# Memorandum

To	Peter Olak, P.Eng.	Page 1
CC	Dean Simpson, P.E., Zaineb Al Mumayez, P.Eng.	
Subject	<b>Geotechnical Review- Hamilton Rapid Transit Preliminary Design and Feasibility Study (B-line), September 2011</b>	
From	Gwangha Roh, P.Eng., Ph.D., Eric Tiedje, EIT, Ph.D., Miln Harvey, P.Eng., Ph.D.	
Date	October 14, 2016	Project Number 60507521

This memorandum presents a review summary of geotechnical evaluation and provides additional preliminary recommendations to finalize the B-line geotechnical EA report.

**Figure 4.2.1. Typical Stop Platform Detail**  
(SDG B-Line EA Report, Appendix B.7, Figure 5.2).

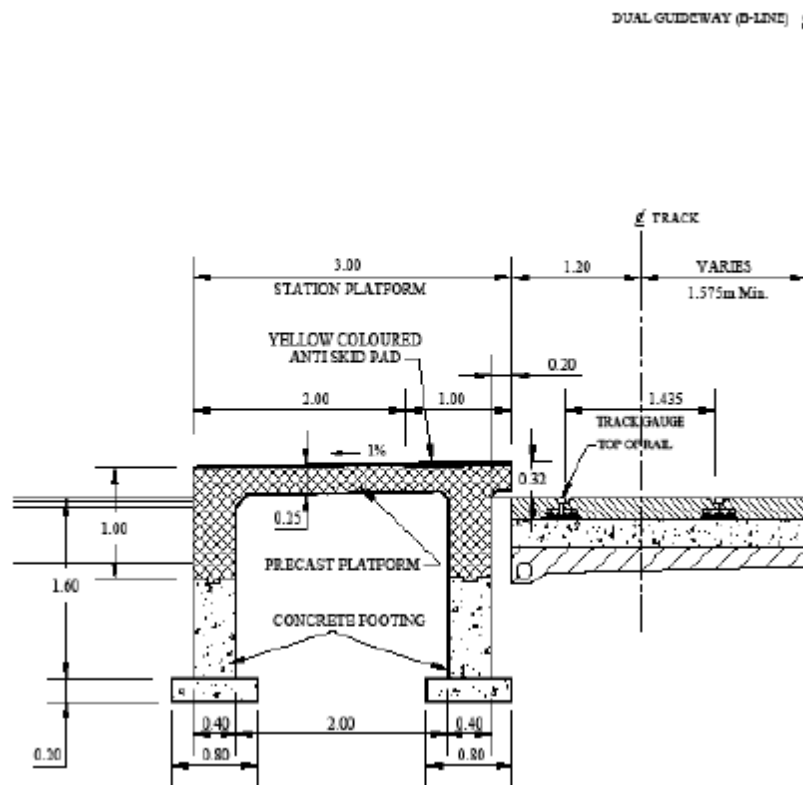
Although the geotechnical EA report noted that foundations should be placed below the frost depth (1.2 m), the typical stop platform detail presented in the geotechnical EA report has about 1.8 m of earth cover, reprinted in Figure 4.2.1. This may be due to site-specific subsurface and groundwater conditions. It is suggested to present a minimum frost cover requirement (1.2 m) on the typical drawing instead of site-specific foundation depth.

In case of using short caisson foundations in a frost susceptible soil with a high groundwater table, adfreezing/frost heave uplift mitigation should also be considered.

PRELIMINARY DESIGN  
GUIDEWAY OVER HWY 403  
GENERAL ARRANGEMENT 1/2

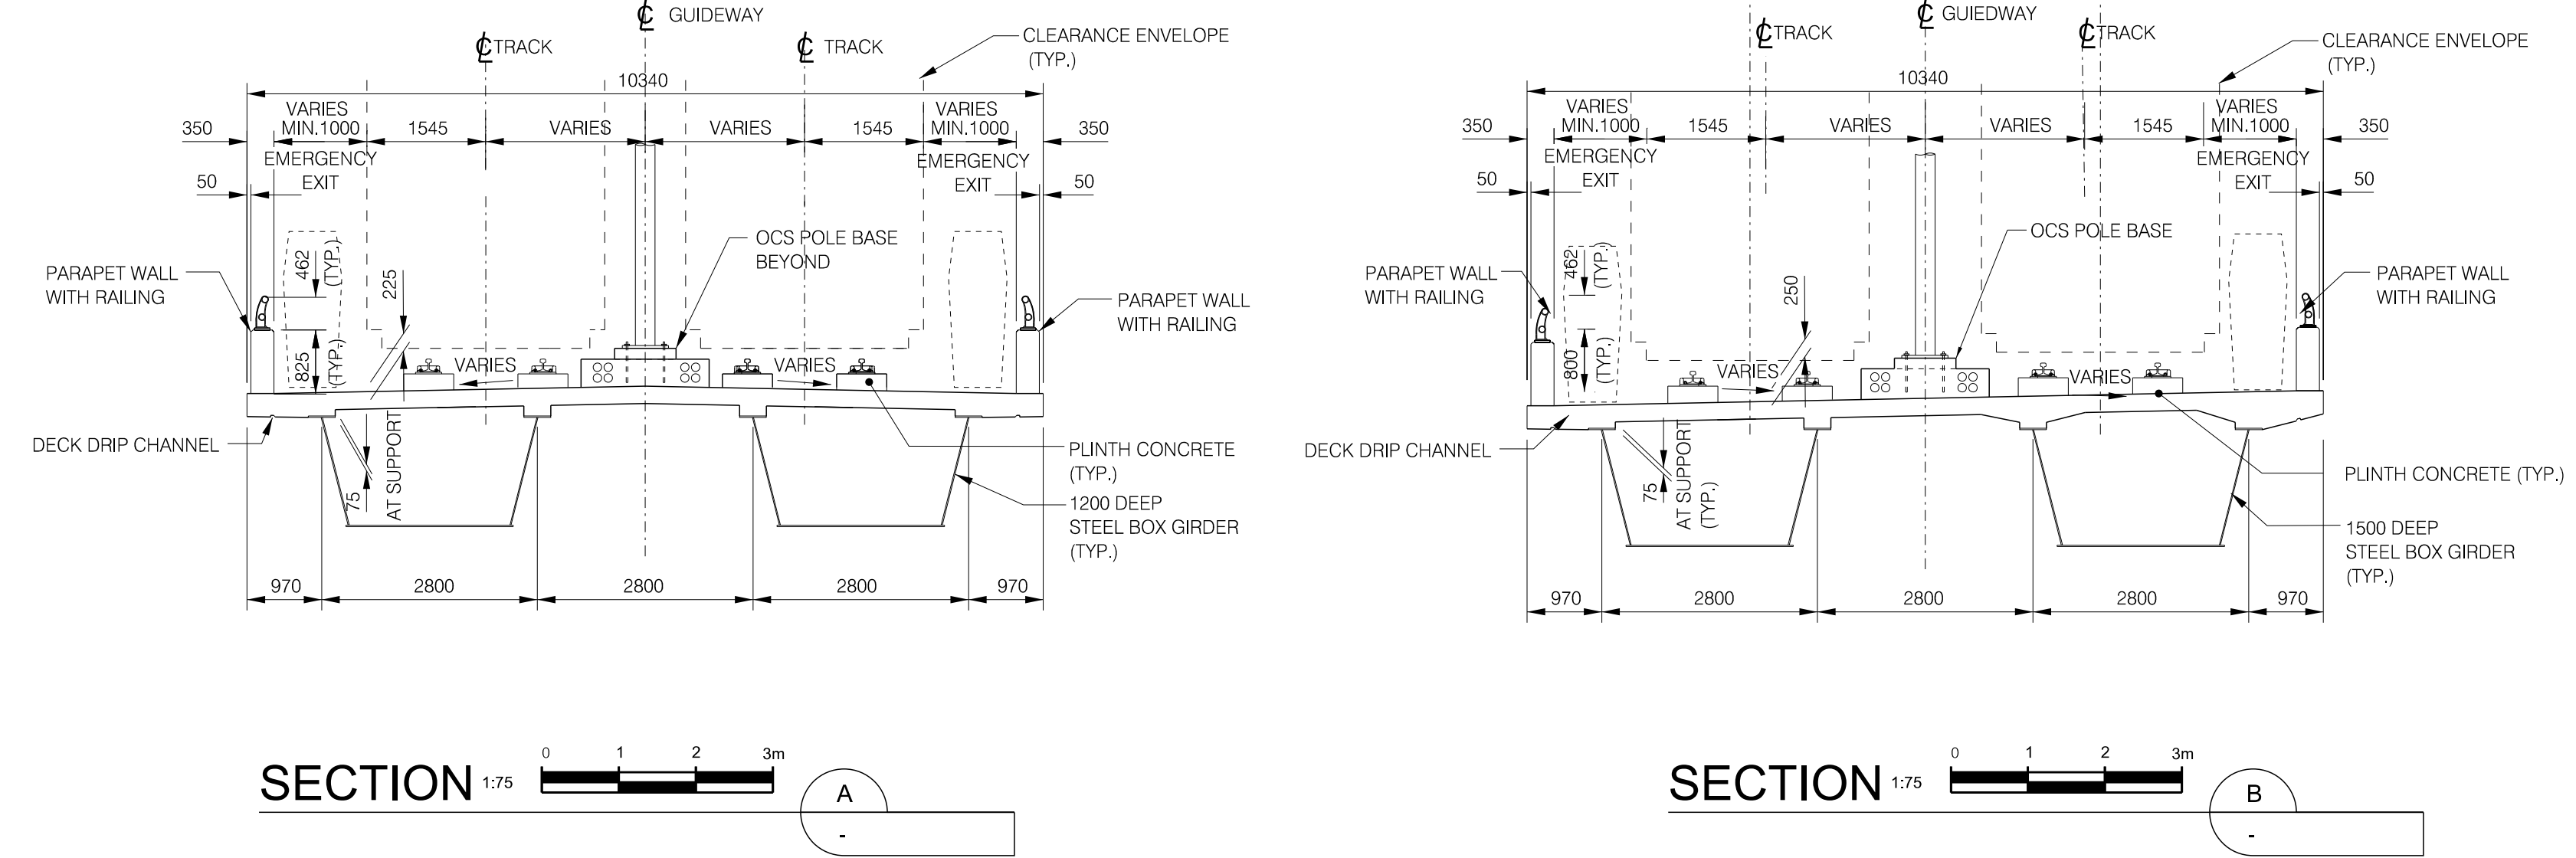
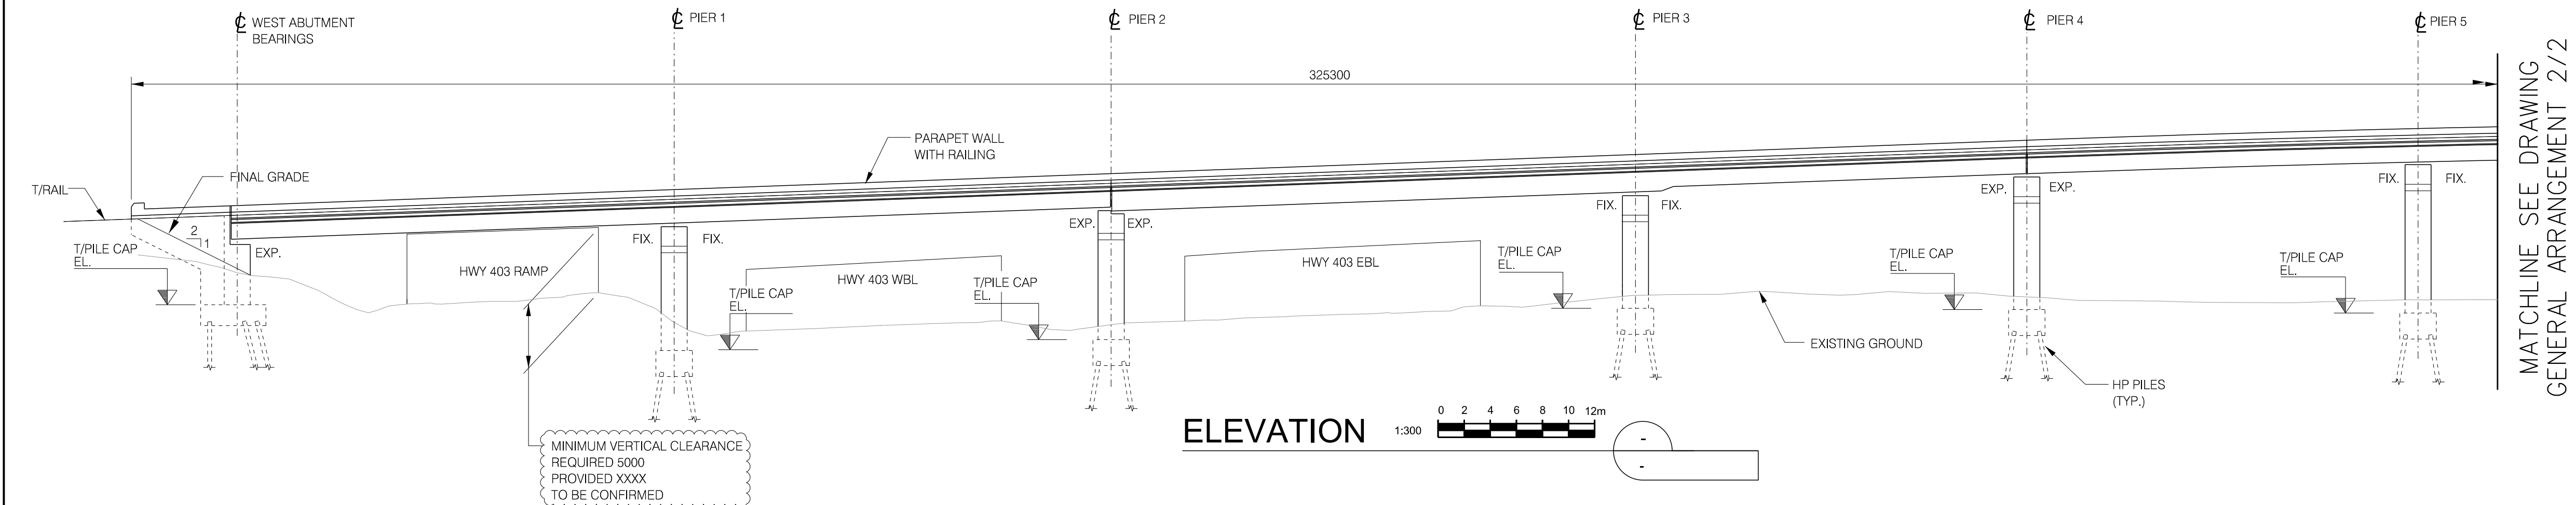
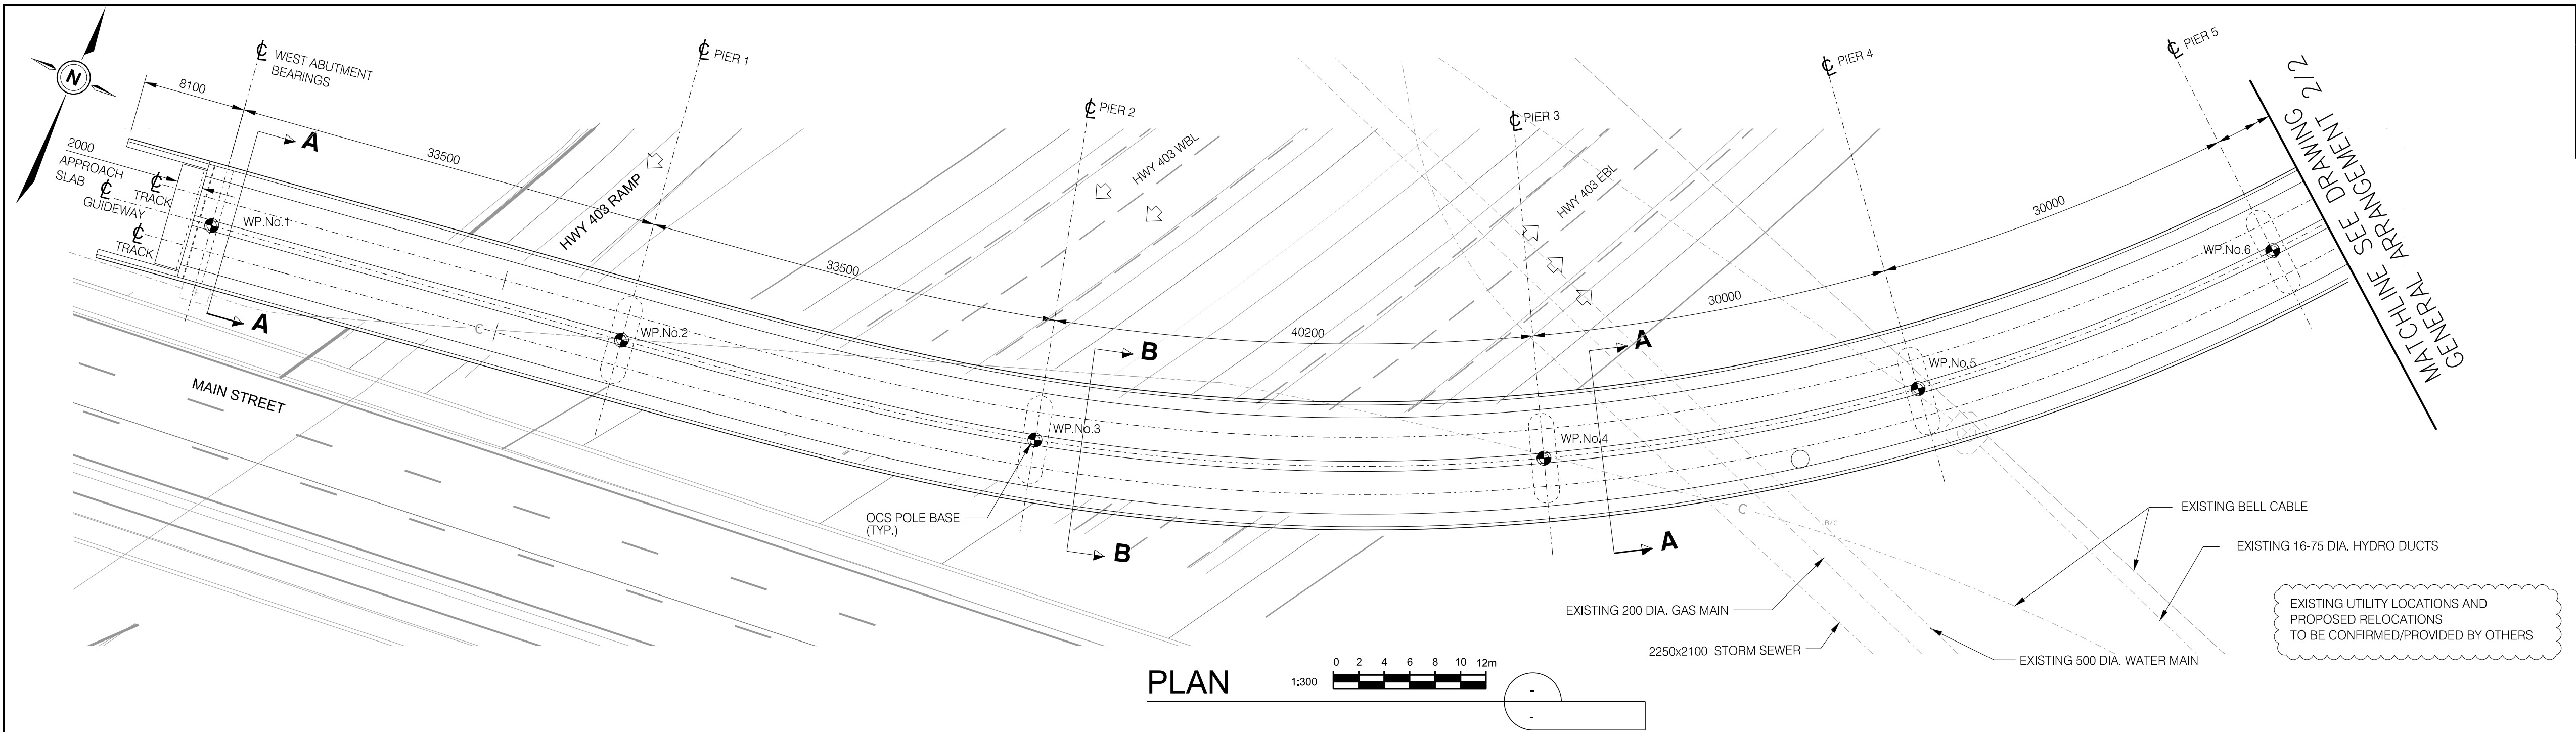
AECOM has prepared General Arrangement drawings (see Appendix A) for a 10-span highway bridge which will carry two LRT tracks over Highway 403 between Main Street West and King Street West. This structure can be supported on deep foundations such as driven steel H-piles or cast-in-place concrete caissons.

It should be noted that a buried CSO storage tank and outfall channel are located between King Street West and Main Street West on the east side of the Highway 403 and the exact location and depth of these structures should be considered for the detailed bridge foundation design.

The provided driven H-pile capacities (a factored geotechnical axial resistance of 1600 kN/pile at ULS and geotechnical axial reaction of 1200 kN/pile at SLS, for HP 310x110) may be based on the previous MTO pile load test results (in early 1960's, GEOCRE 30M05-65) in the vicinity and the old MTO driven pile capacity guidelines. MTO driven H-pile capacity limits have been changed as outlined in Table 4.4.1:

The use of wing walls or RSS walls at the abutment locations is not clearly identified. Approach fill details are not known. Embankment and retaining structure stability and serviceability (settlement) should be assessed in the detailed design stage.

It is suggested that dynamic pile load tests be performed (e.g. PDA, CAPWAP etc.) to confirm the design pile capacity for a cost-effective foundation design.

Typical rock-shale adhesion of 400 to 800 kPa (factored) can be used for cast-in-place concrete pile designs (socketed into bedrock) depending on the bedrock quality. Rock socketed caisson capacity can be verified by field tests (e.g. Osterberg cell). Typically rock socketed caissons use either shaft resistance or end bearing only depending on construction details due to the anticipated strain related pile resistance development.
